29TH JULY 1884, No. 1837 W., PUBLIC WORKS.

In compliance with G.O., Public Works Department, No. 2294 W., dated 6th September 1879, I have the honor to submit a proposed standard design for a Sub-Judge or District Munsif's court with terraced roofing.

Sub-Judge's or District
Munsif's Court

Ordering, with remarks, preparation of a
type design for a —.

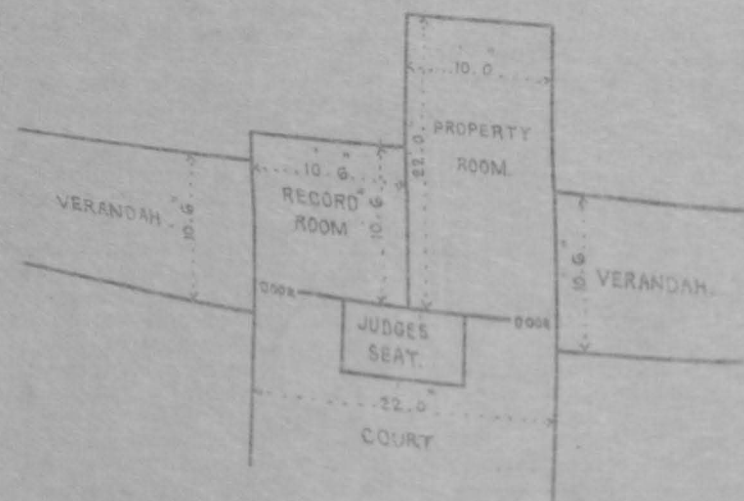
3. The record and property rooms can, if considered preferable, be both placed in rear of the court and touching it thus:—

their sizes will then be—

Record-room, 10½ feet square and 17 feet high.
Property room, 22 by 10½ feet.

and the two wings of the building, as viewed from the front, will then be symmetrical.

2. With reference to the suggestion made by the Consulting Architect in paragraph 3 of his letter as to the situation of the record-room, the Honorable the Chief Justice is of opinion that it would be as well to bear the proposal in mind as an alternative arrangement, and that uniformity in the wings of a building is not always desirable; but Mr. Justices Hutchins and Brandt think it preferable to locate the record-room near the property room at the back as proposed by the Consulting Architect.

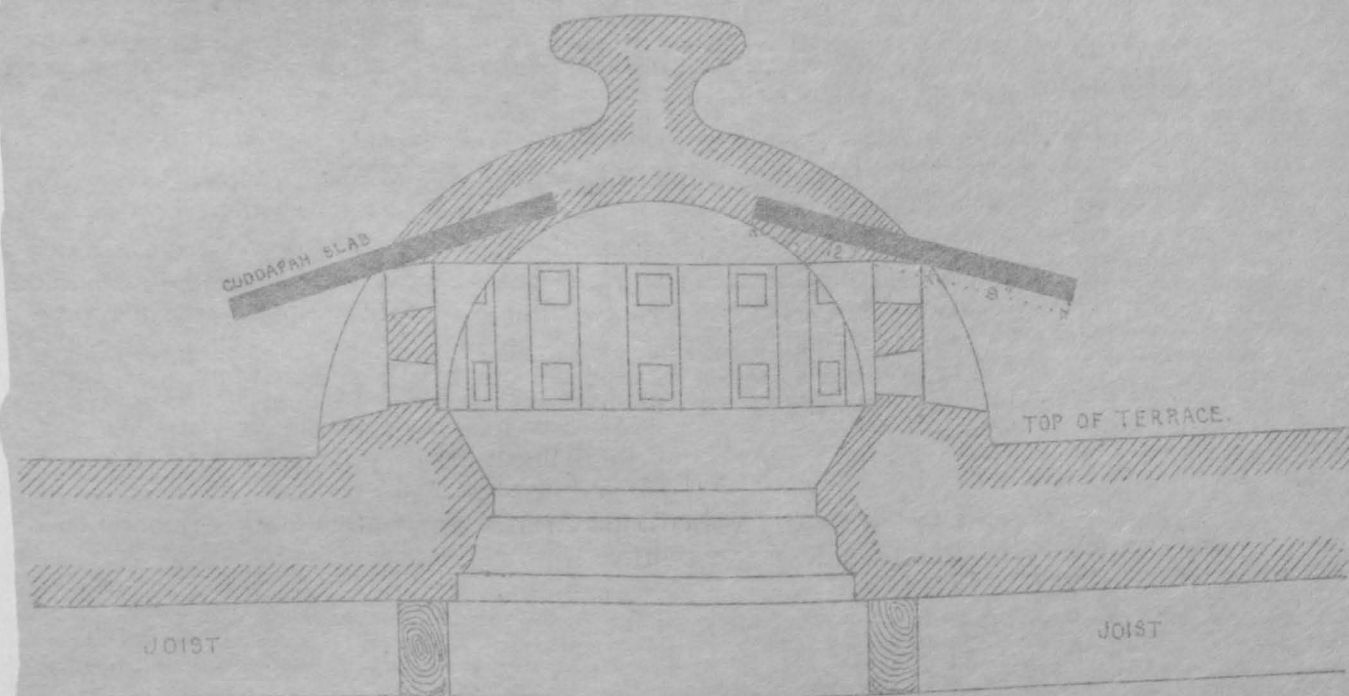
5. The small dome over the roof of the muntapam and the still smaller ones over that of the latrine are for giving light and ventilation by apertures in their sides: these are hidden from view in the plans now sent by the parapet wall. If thought desirable, similar domical skylights could be placed over the court to increase its ventilation, and, were this also required, its light. The section below explains the construction of these ventilators.

3. As to the suggestions made in paragraph 5 of Major Morant's letter, the Court considers that it is very essential that light and ventilation should be secured in the manner proposed.

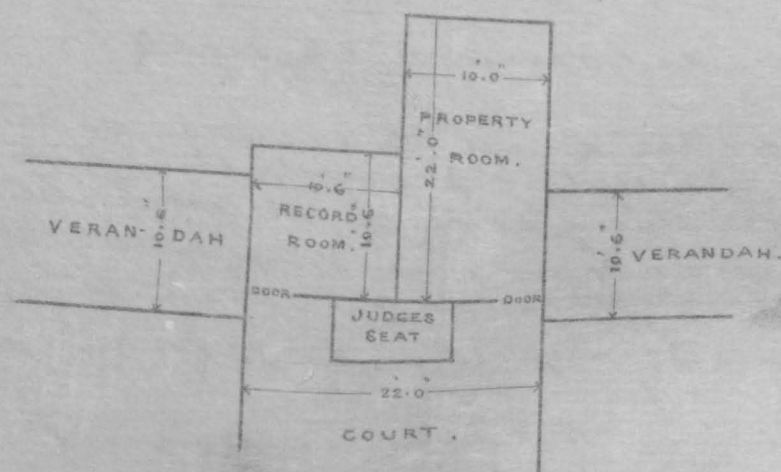
3. The Record and Property Rooms can, if considered preferable, be both placed in rear of the Court and touching it thus:-

their sizes will then be.

Record Room 10½ feet square and 17 ft high

2. With reference to the suggestion made by the Consulting Architect in para 3 of his letter as to the situation of the Record Room, the Honourable the Chief Justice is of opinion that it would be as well to bear the proposal in mind as an alternative arrangement and that uniformity in the wings of a building is not always desirable, but Mr. Justices Hutchins and Grandt think it preferable to locate the record room ^{mean the proposed position} at the back as proposed by the Consulting Architect.

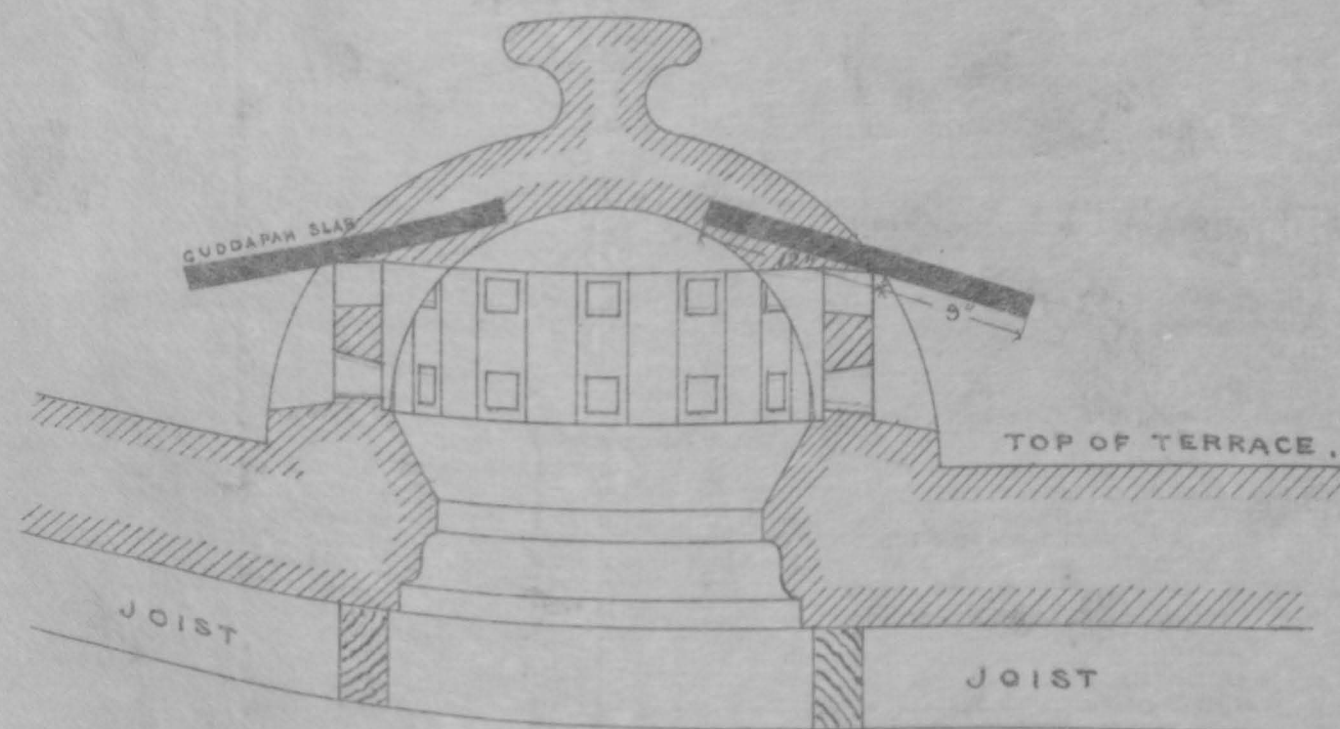
4. The design provides for the usual verandahs. And the rooms of the building are still further protected from the sun by stone slabs colored blue in the drawing projecting both beyond the verandahs and over the clear storey ventilators. Under cover of these

slabs permanent ventilation can easily be arranged. The space which these projections shade is shewn by dotted lines on the ground plans of all the buildings.

5. The small dome over the roof of the Muntapam and the still smaller ones over that of the latrine are for giving light and ventilation by apertures in their sides; these are hidden from view in the plans now sent by the parapet wall. If thought desirable similar domical skylights could be placed over the Court to increase its ventilation and, were this also required, its light. The section below explains the construction of these ventilators.

3. As to the suggestions made in para 5 of Major Morant's letter, the Court considers that it is very essential that light and ventilation should be secured in the manner proposed.
